DUKE POWER COMPANY
OCONEE NUCLEAR STATION

Proposed Technical Specification Revision

Figure 3.1.2-1A

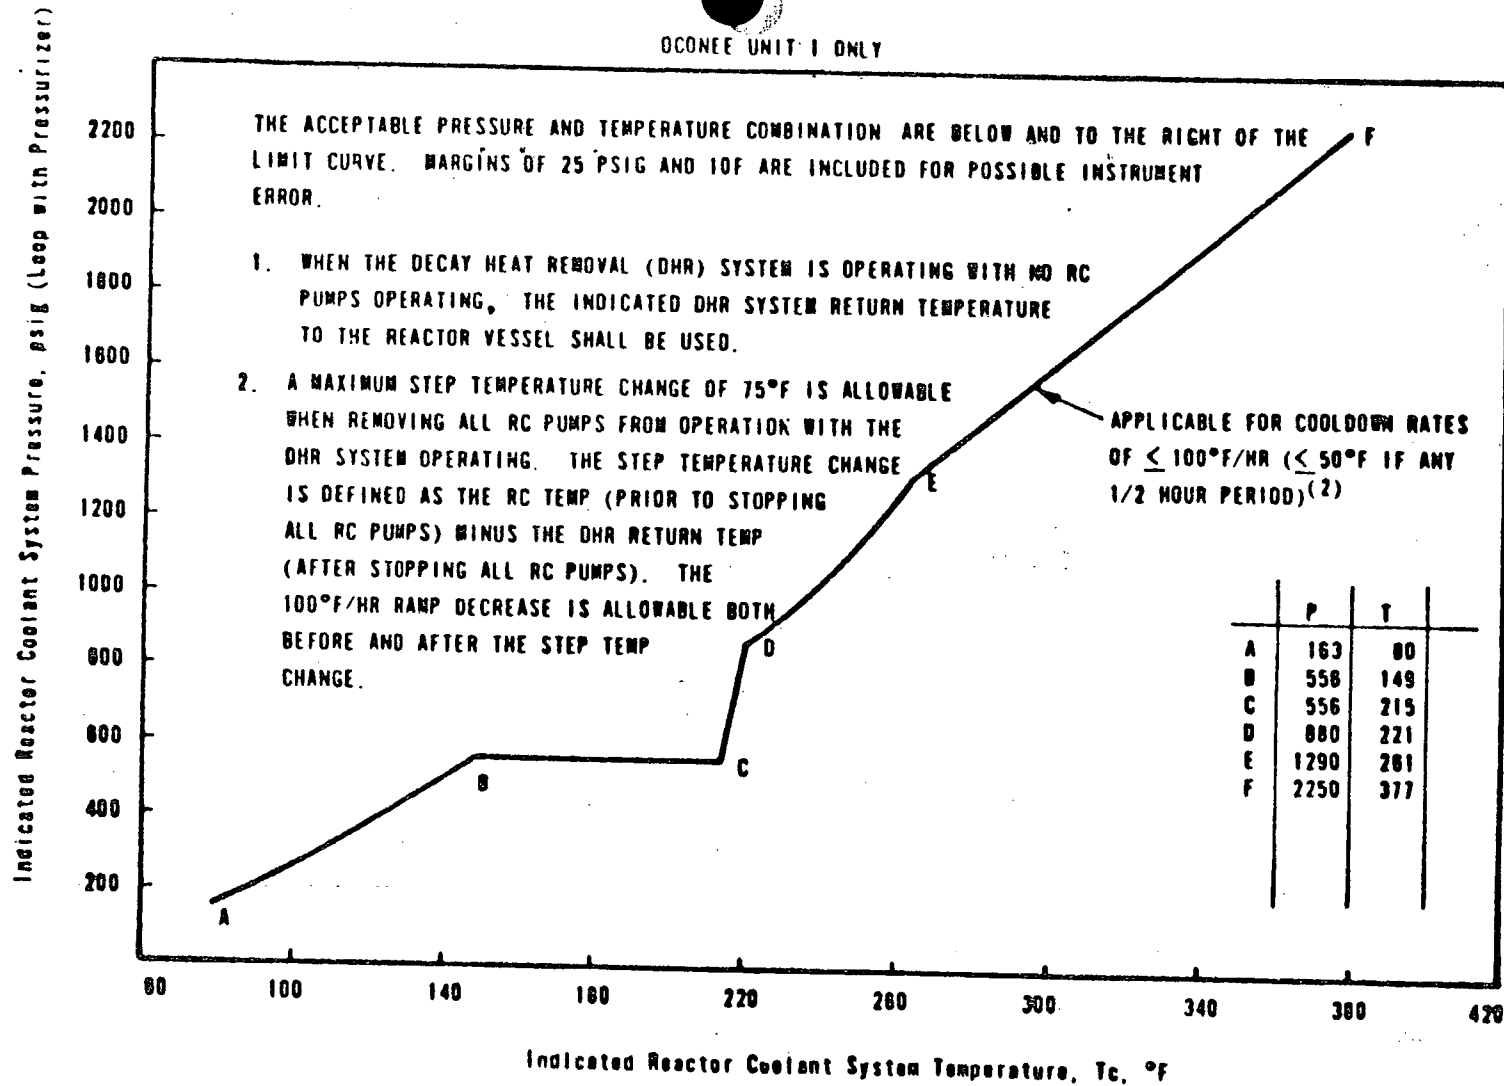
REACTOR COOLANT SYSTEM
 NORMAL OPERATION-HEATUP LIMITATIONS APPLICABLE FOR FIRST
 6.0 EFFECTIVE FULL POWER
 YEARS

UNIT 1
 OCONEE NUCLEAR STATION
